9 REABY STREET PORTARLINGTON: 2 LOT SUBDIVISION

PLANNING AMENDMENT

AMENDMENT:
REMOVE PROPOSED
FREESTANDING SINGLE
CARPORT WITH SEPARATE
DRIVEWAY & CROSSOVER TO
THE EXISTING UNIT 1
DWELLING

AMENDMENT:
PROPOSED NEW SINGLE
GARAGE IS INCORPORATED
UNDER THE EXISTING UNIT 1
DWELLING WITH SEPARATE
DRIVEWAY FROM THE SOUTH-
WEST CORNER OF THE
PROPERTY

1 PROPOSED SITE - COUNCIL APPROVED
1 : 200

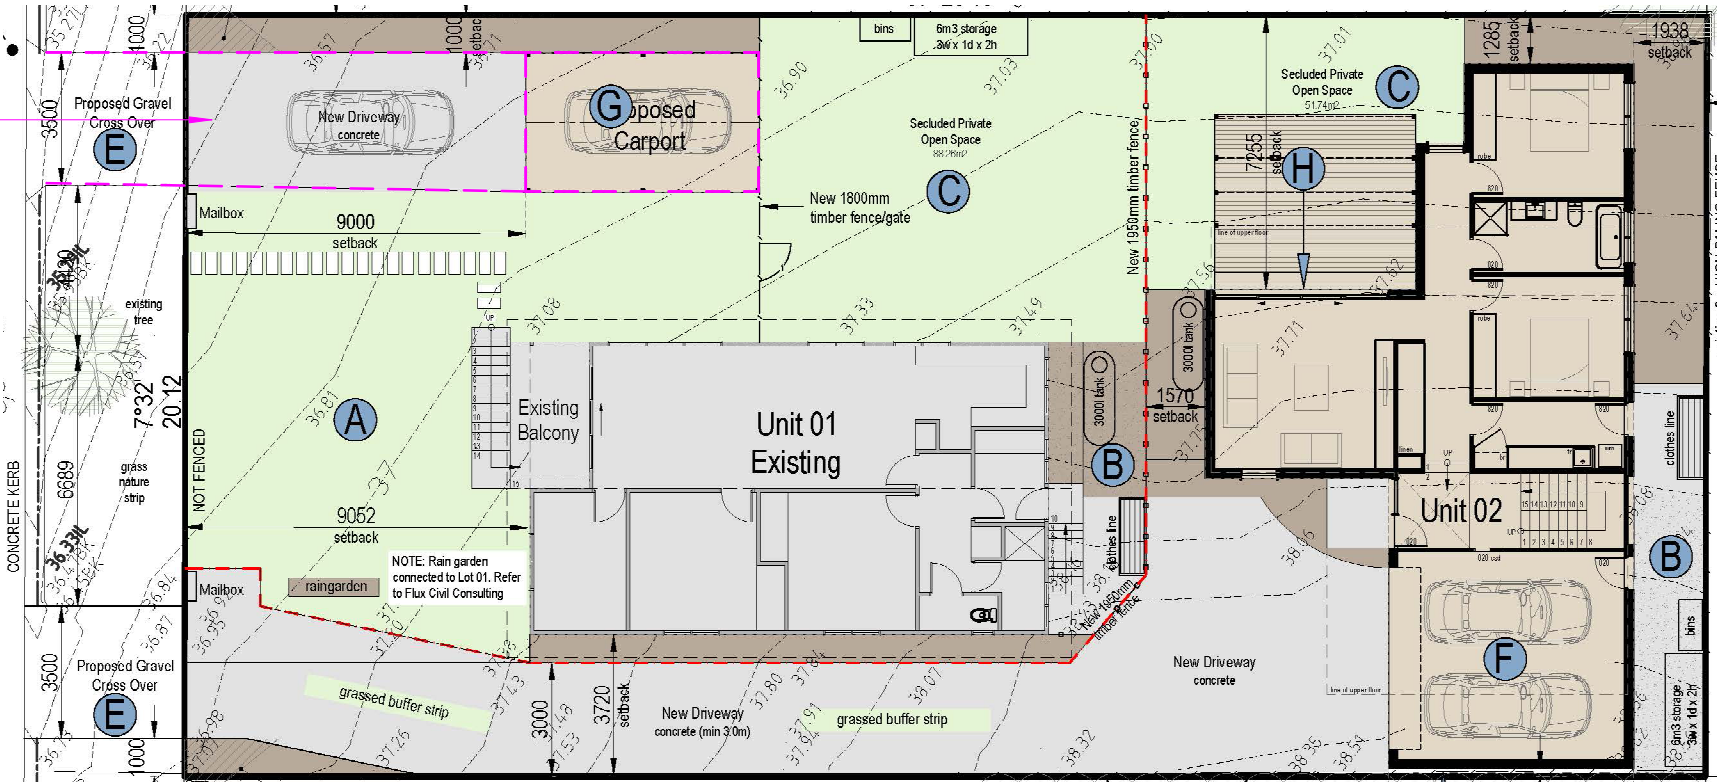
PROPOSAL
A PROPOSED FREESTANDING SINGLE CARPORT WITH SEPARATE DRIVEWAY & CROSSOVER TO THE EXISTING DWELLING WAS REQUIRED FOR THE 2 LOT SUBDIVISION COUNCIL APPROVAL, LOCATED AT THE NORTH-WEST CORNER OF THE PROPERTY

IMPACTS
A PROPOSED FREESTANDING SINGLE CARPORT WITH SEPARATE DRIVEWAY & CROSSOVER TO THE EXISTING DWELLING IS DISADVANTAGEOUS IN THAT IT:

- OCCUPIES PRIME NORTH FACING SECLUDED PRIVATE OPEN SPACE
- RESULTS IN 2 SEPARATE CROSSOVERS AT THE PROPERTY
- REQUIRES RELOCATION OF BARWON WATER METER & MAIN
- INCREASES VISUAL BULK & HAS A NEGATIVE IMPACT ON STREETSCAPE APPEARANCE & ON ADJOINING PROPERTIES
- REDUCES SCOPE FOR PLANTING & LANDSCAPING

2 PROPOSED SITE - AMENDED
1 : 200

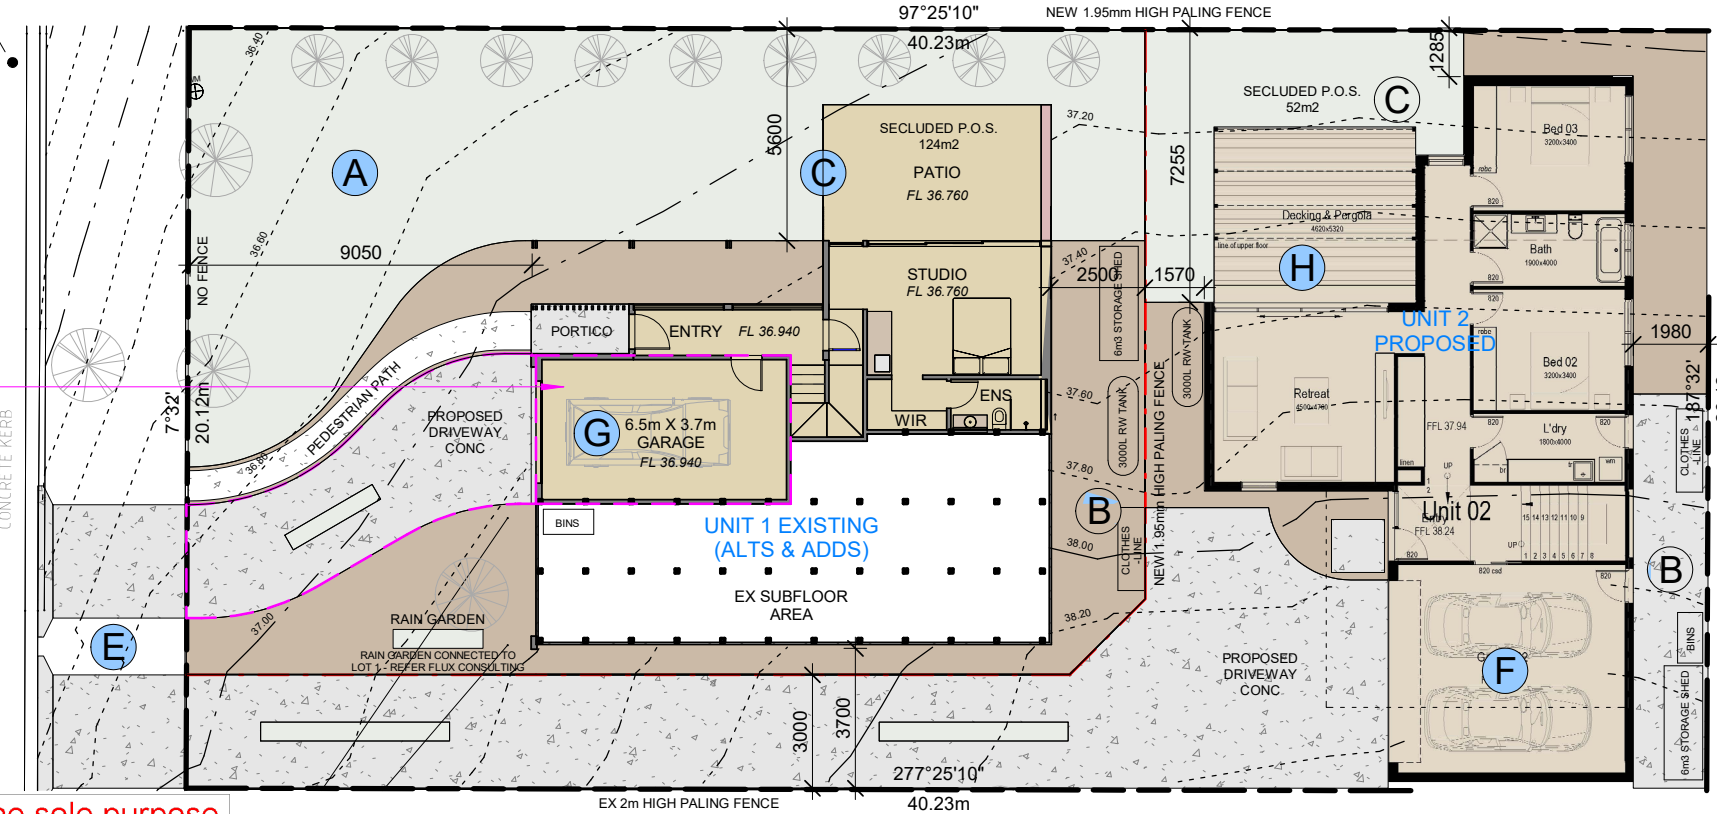
2. PROPOSED AMENDMENT TO COUNCIL APPROVED PLANS

PROPOSAL
PROPOSED NEW SINGLE GARAGE IS INCORPORATED UNDER THE EXISTING UNIT 1 DWELLING WITH DRIVEWAY FROM THE SOUTH-WEST CORNER OF THE PROPERTY

IMPACTS
ADVANTAGES OF THIS DRIVEWAY & CARPORT ARRANGEMENT INCLUDE:

- MAXIMISES PRIME NORTH FACING SECLUDED PRIVATE OPEN SPACE FOR EXISTING UNIT No.1
- ELIMINATES OVERSHADOWING OF UNIT P.O.S. WITH RELOCATION OF CARPORT
- RESULTS IN ONLY ONE (WIDER) CROSSOVER AT THE PROPERTY
- MINIMISES VISUAL BULK & A POSITIVE IMPACT ON STREETSCAPE APPEARANCE & ON ADJOINING PROPERTIES
- INCREASED SCOPE FOR PLANTING & LANDSCAPING

PROPOSED SITE PLAN
SHEET D04

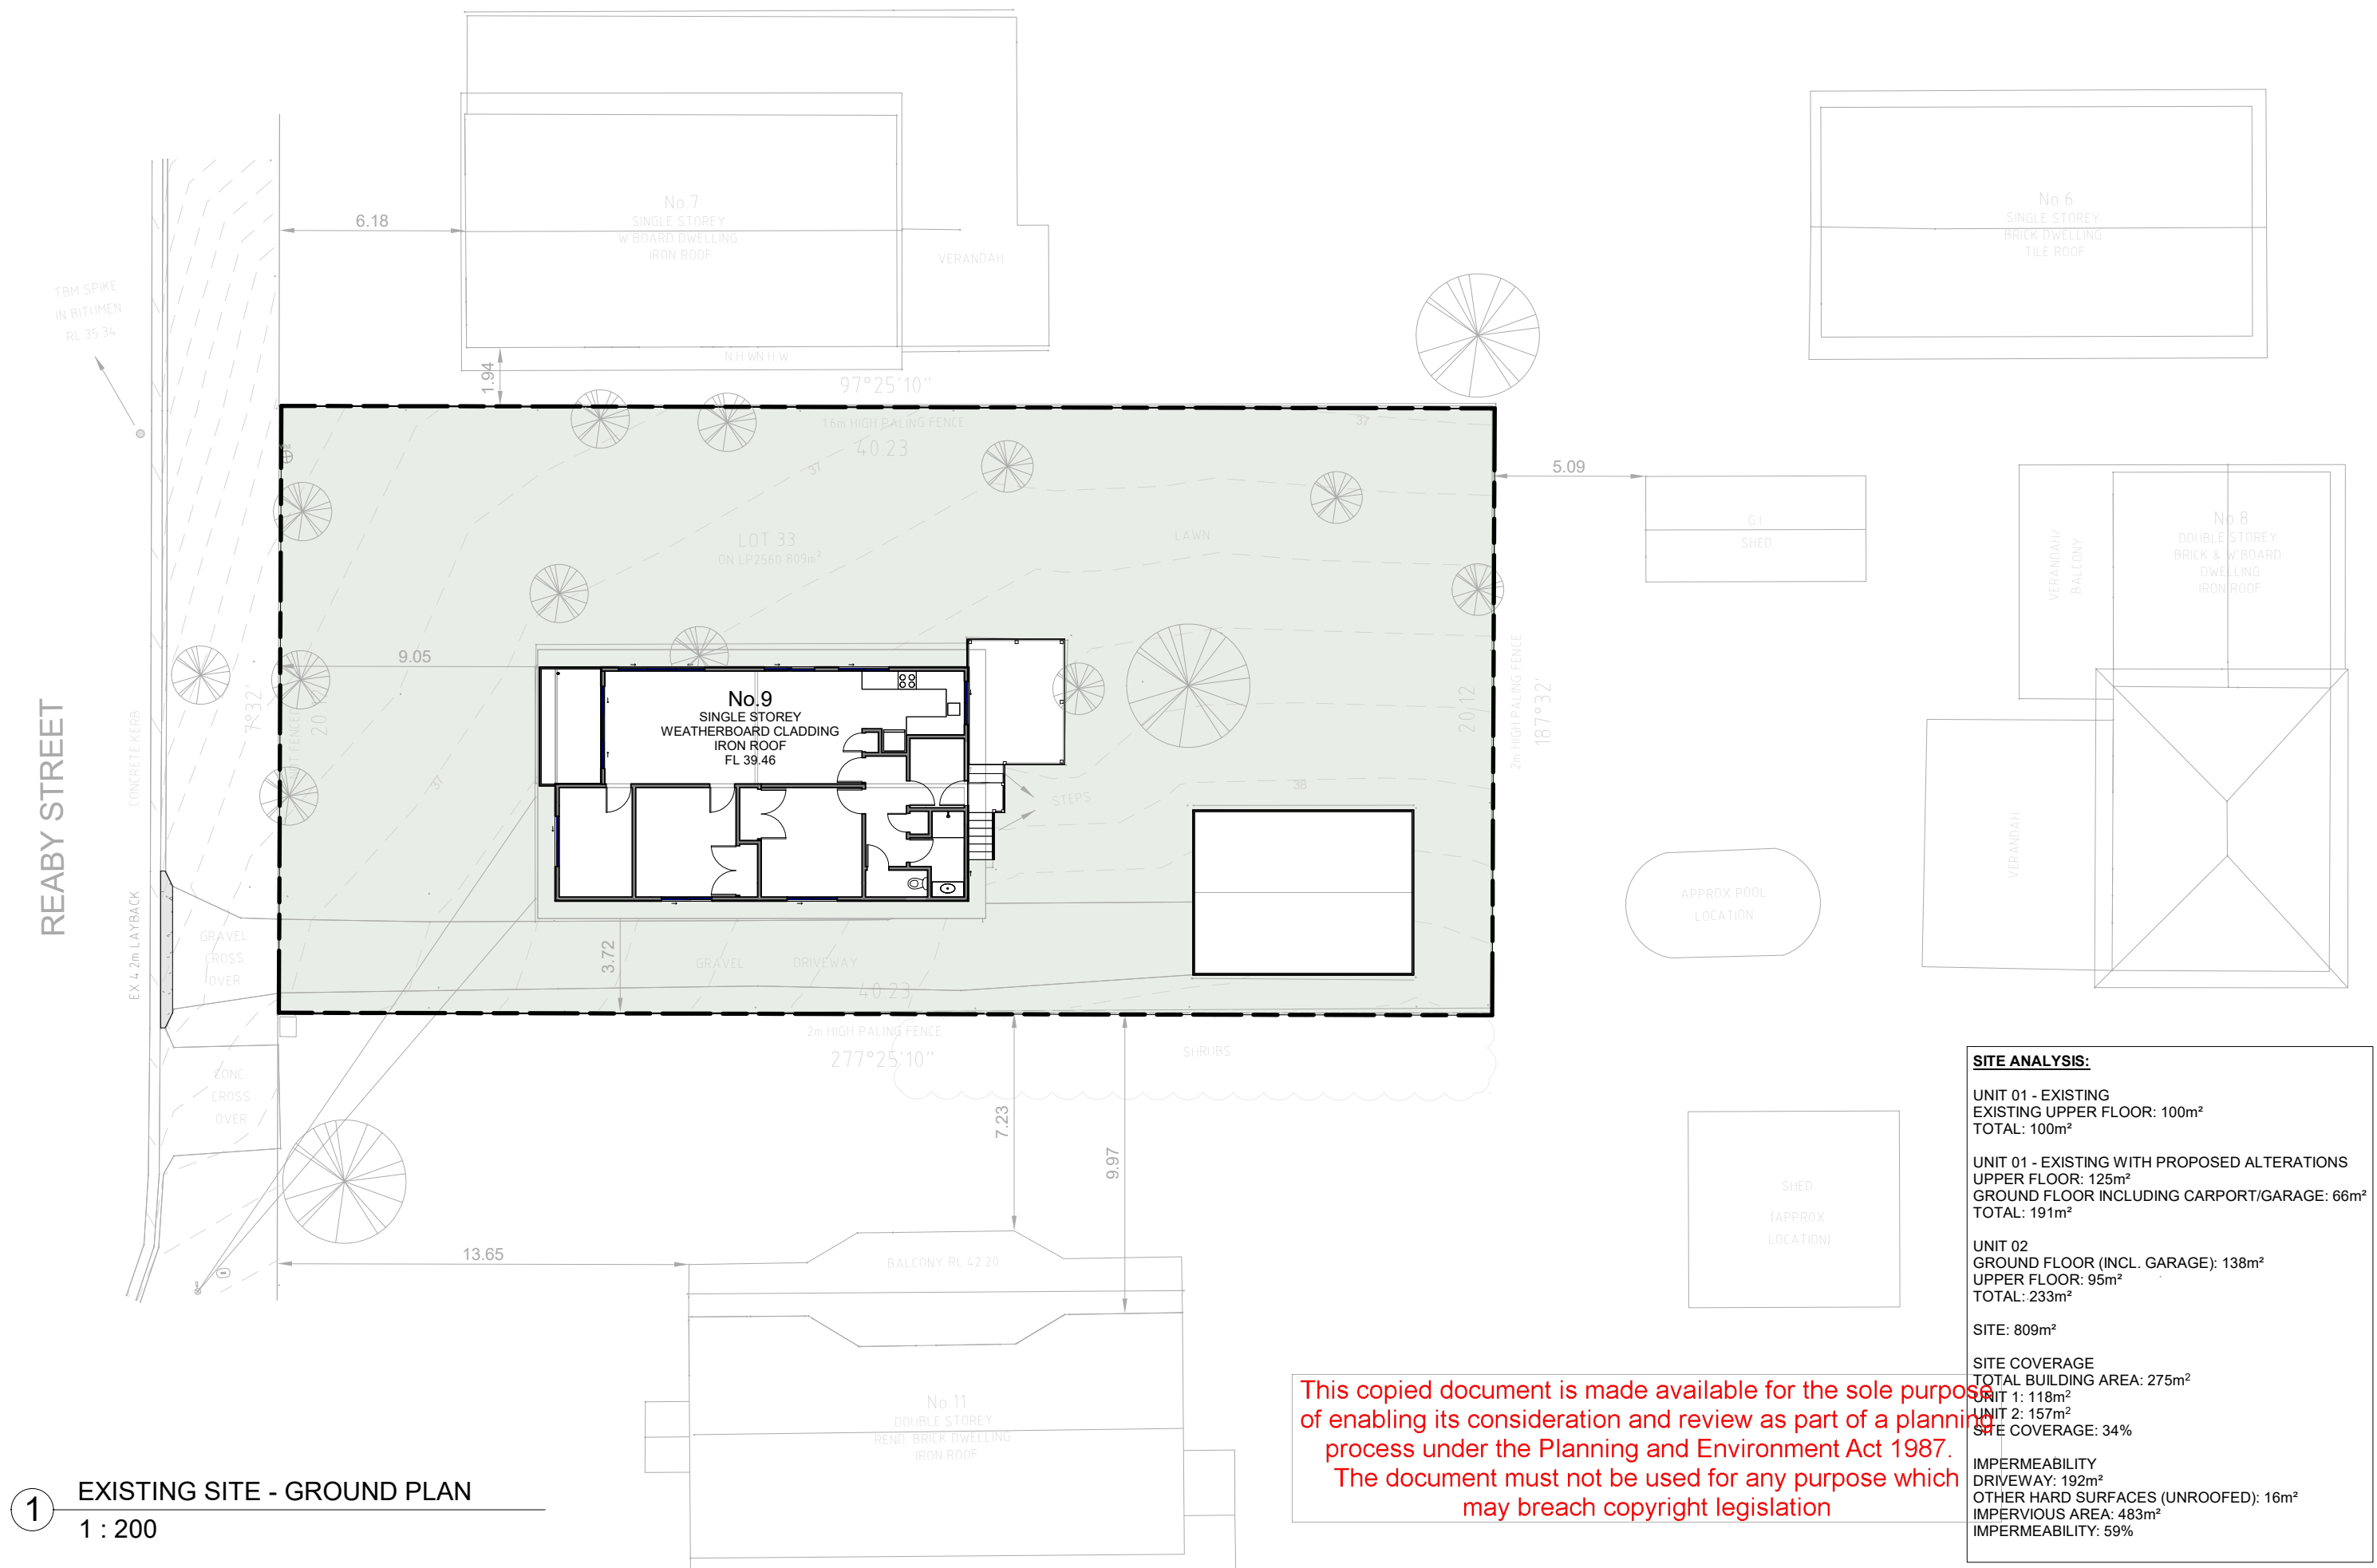
AMENDMENT:
REMOVE PROPOSED
FREESTANDING
SINGLE CARPORT
WITH SEPARATE
DRIVEWAY &
CROSSOVER TO THE
EXISTING UNIT 1
DWELLING

AMENDMENT:
PROPOSED NEW
SINGLE GARAGE IS
INCORPORATED
UNDER THE
EXISTING UNIT 1
DWELLING WITH
SEPARATE
DRIVEWAY FROM
THE SOUTH-WEST
CORNER OF THE
PROPERTY
